Proposal for the 06 series of amendments of UN Regulation No. 22 (Protective helmets)

Submitted by the experts from the Informal Working Group on UN Regulation No. 22

The text reproduced below was prepared Submitted by the experts from the Informal Working Group on UN Regulation No. 22 aiming to introduce some corrigendum to the approved proposal. Modifications to document ECE/TRANS/WP.29/2019/25 are marked in bold for new or strikethrough for deleted characters.

Figure 2A - PERIPHERAL VISION

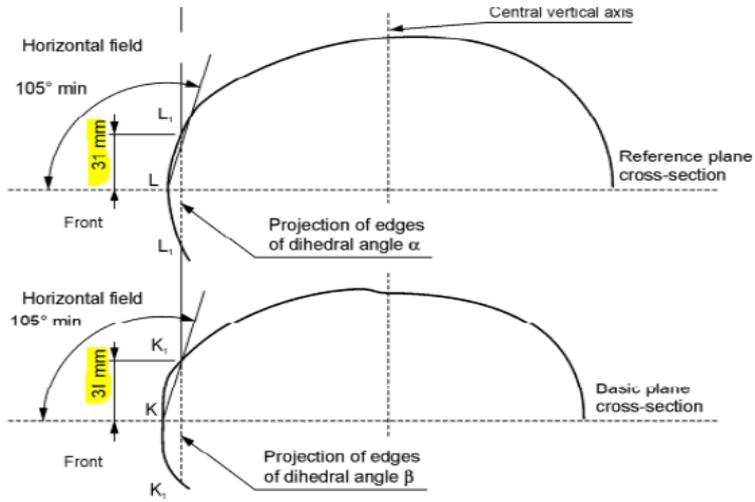
Figure 2A – measure 31 shall be modified as 32 in line with paragraph 6.16.3.8.:
